Duquesne Light

Reference: Beaver Valley Power Station, Unit No. 1
Docket No. 50-334, License No. DPR-66
Environmental Qualification of Safety-
Related Electrical Equipment

EQUIPMENT QUALIFICATION ITEMS SUMMARY

JUSTIFICATIONS FOR CONTINUED OPERATION

FIGURE 1
 TYPICAL LIMIT SWITCH "SEAL-IN" CIRCUIT
 FOR CONTAINMENT ISOLATION VALVE

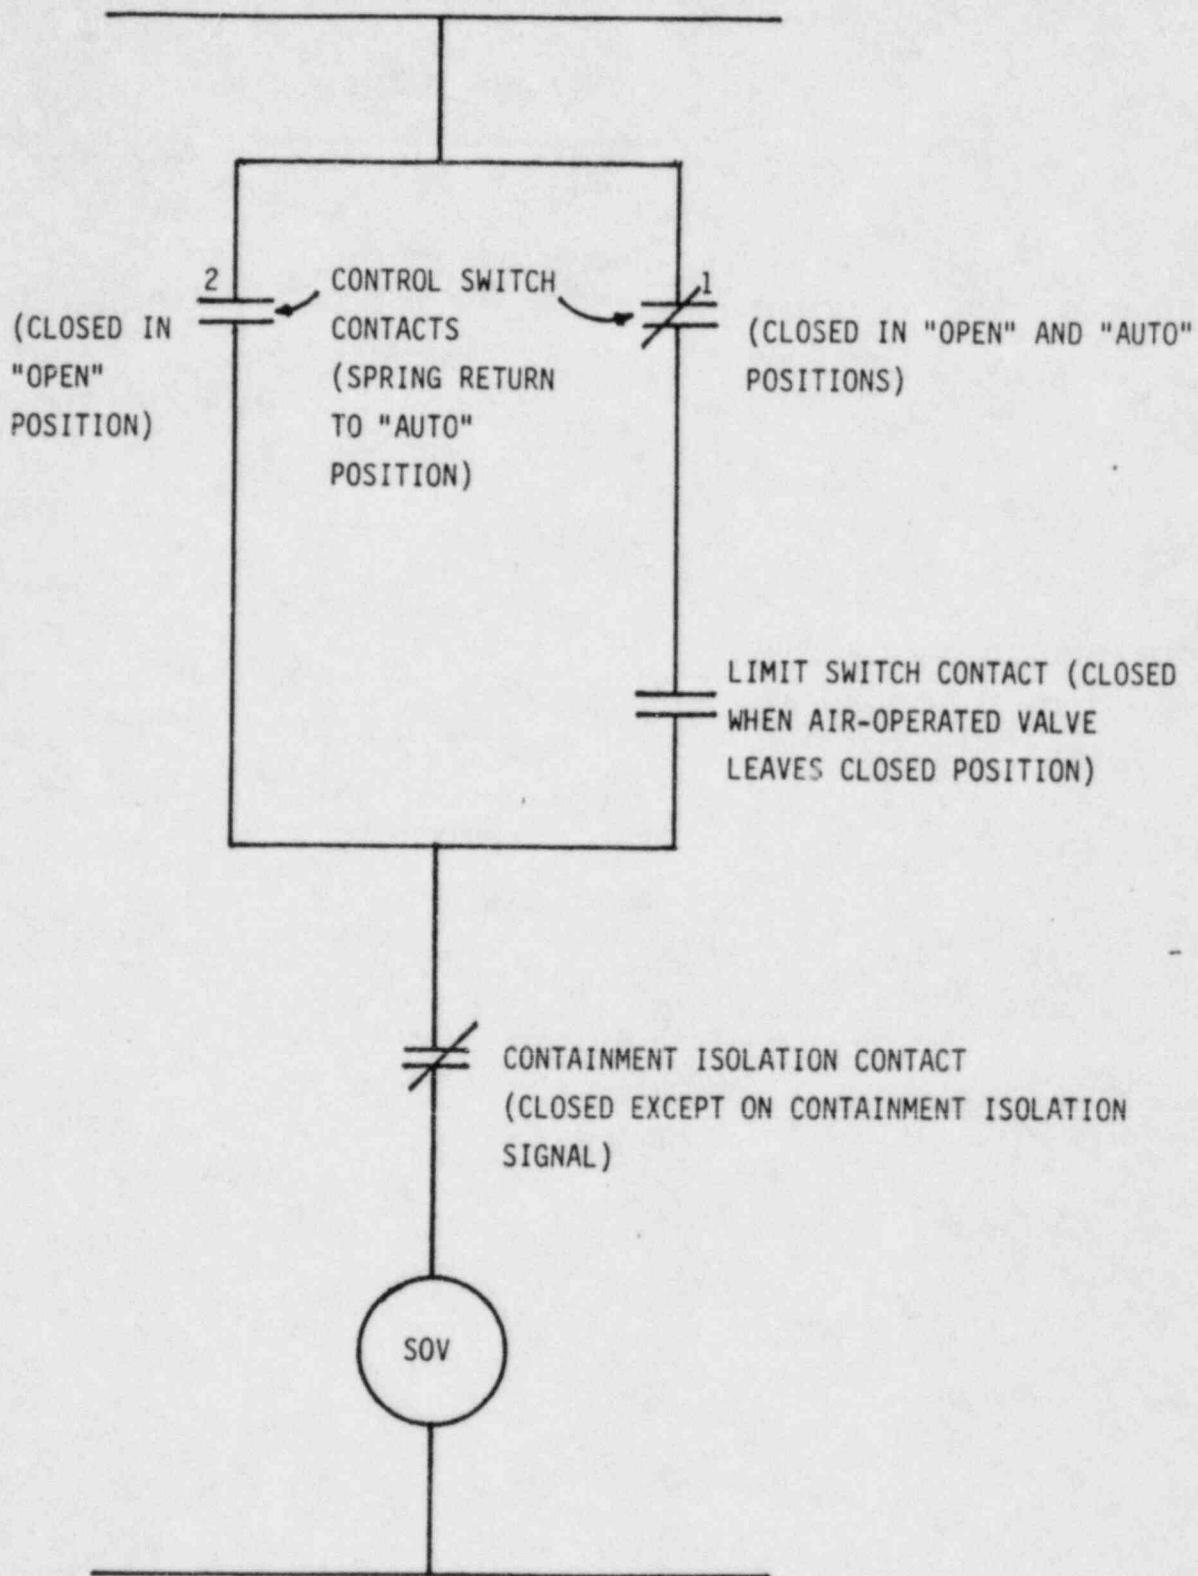
Inadequate steam exposure.

The switches can fail open, grounded, or closed. A failure mode and effects analysis shows that for each failure mode two initial conditions for the associated solenoid must be considered: Solenoid initially energized and solenoid initially de-energized.

With the solenoid initially energized, limit switch failures will affect the solenoid and air-operated valve as follows. If the switch fails open, it will de-energize the solenoid and cause the associated air-operated valve to go to its fail safe position (closed) and need not be considered any further. A failure resulting in a single ground would have no effect on the battery power supply which is ungrounded. Multiple grounds could result in a trip of the circuit breaker that feeds the solenoid. This failure would cause de-energization of the solenoid resulting in the associated air-operated valve going to its fail safe position (closed) (Refer to Figure 1). This type of failure would be analogous to loss of air supply to the valve.

If the solenoid is initially de-energized it will be due to any of three possible conditions, not including the limit switch failure itself. These conditions are (1) loss of power, (2) control switch failed open or held continuously in CLOSE position, and (3) containment isolation signal. For the first two conditions, limit switch failure has no effect on the solenoid. For the third condition (containment isolation signal present), should the limit switch fail

open, there would be no immediate effect. Subsequent to the failure, it would not be possible to re-open the air-operated valve unless the control switch were held continuously in the OPEN position. However, this condition has no effect on the ability of the valve to perform its safety function, i.e. to close.

In the event that containment isolation is called for and the limit switch fails closed, the isolation function will be performed as required. However, when the isolation signal is subsequently reset, the failed limit switch would cause its associated solenoid to be re-energized resulting in a re-opening of the air-operated isolation valve (Refer to Figure 1).

FIGURE 1
 TYPICAL LIMIT SWITCH "SEAL-IN" CIRCUIT
 FOR CONTAINMENT ISOLATION VALVE

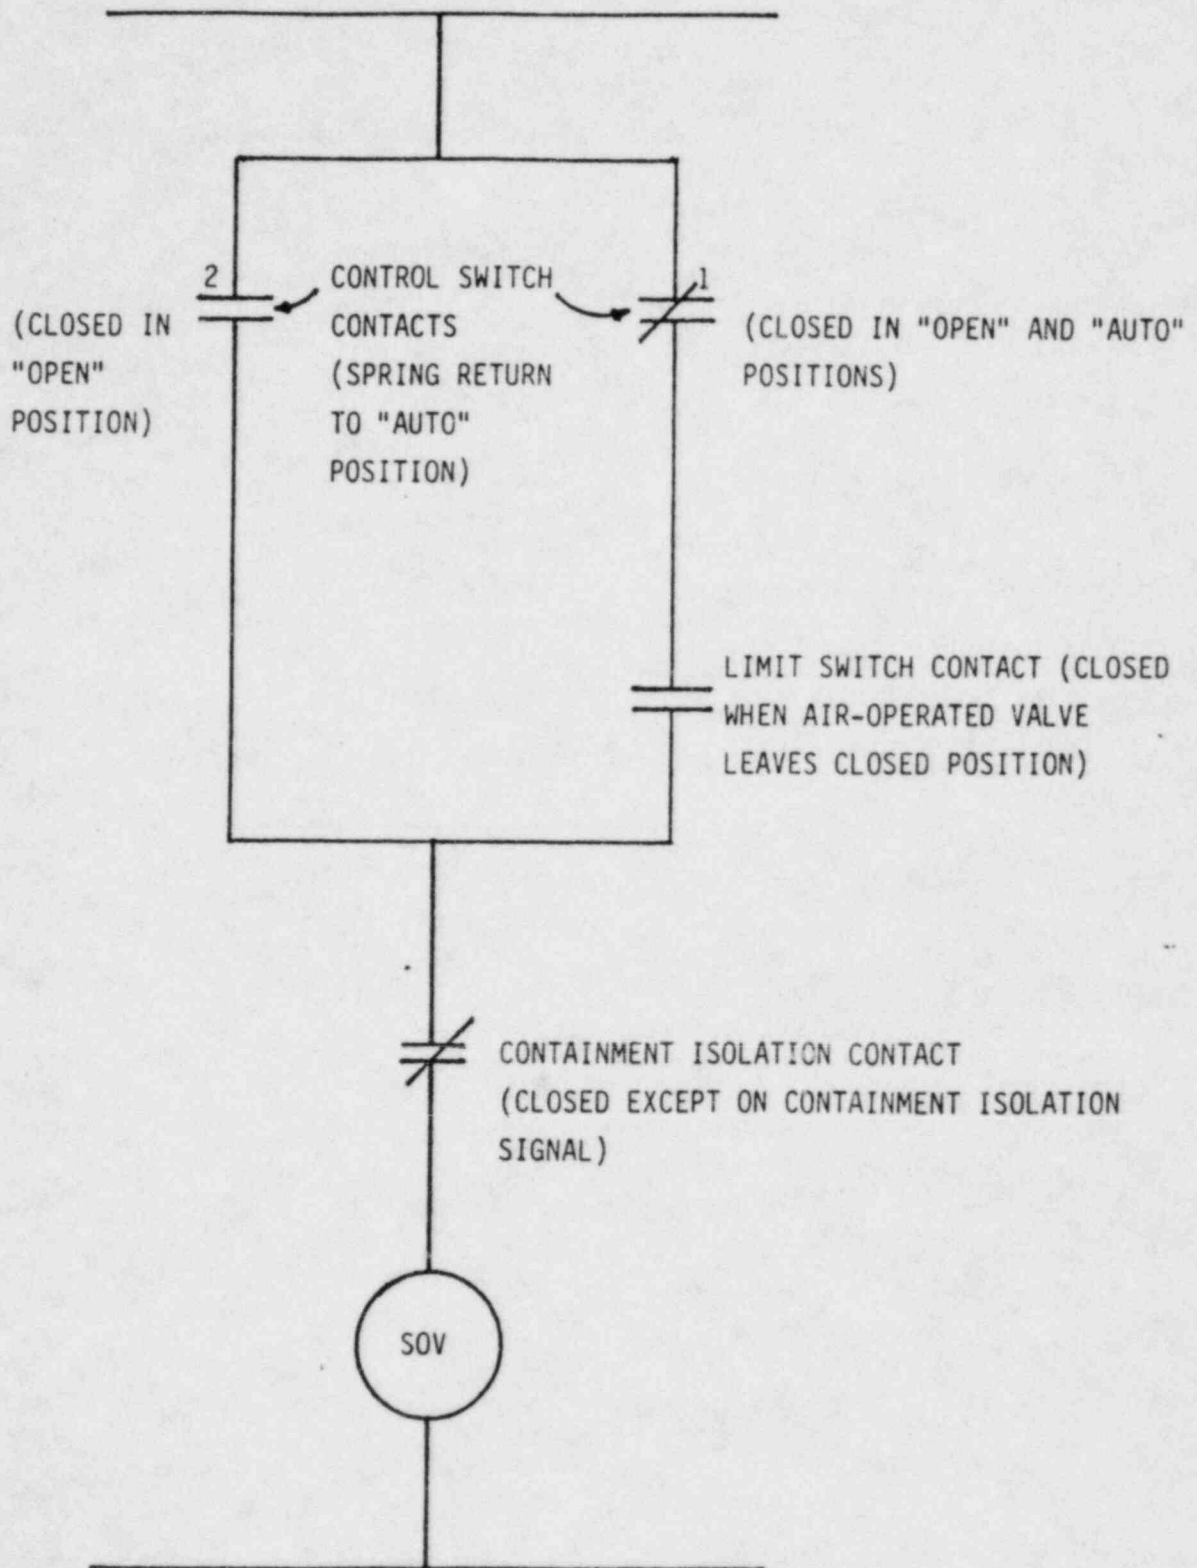
Inadequate steam exposure.

With the solenoid initially energized, limit switch failures will affect the solenoid and air-operated valve as follows. If the switch fails open, it will de-energize the solenoid and cause the associated air-operated valve to go to its fail safe position (closed) and need not be considered any further. A failure resulting in a single ground would have no effect on the battery power supply which is ungrounded. Multiple grounds could result in a trip of the circuit breaker that feeds the solenoid. This failure would cause de-energization of the solenoid resulting in the associated air-operated valve going to its fail safe position (closed) (Refer to Figure 1).

If the solenoid is initially de-energized it will be due to any of three possible conditions, not including the limit switch failure itself. These conditions are (1) loss of power, (2) control switch failed open or held continuously in CLOSE position, and (3) containment isolation signal. For the first two conditions, limit switch failure has no effect on the solenoid. For the third condition (containment isolation signal present) should the limit switch fail open, there would be no immediate effect. Subsequent to the failure, it would not be possible to re-open the air-operated valve unless the control switch were held continuously in the OPEN position. However, this condition has no effect on the ability of the valve to perform its safety function, i.e. to close.

In the event that containment isolation is called for and the limit switch fails closed, the isolation function will be performed as required. However, when the isolation signal is subsequently reset, the failed limit switch would cause its associated solenoid to be re-energized resulting in a re-opening of the air-operated isolation valve (Refer to Figure 1).
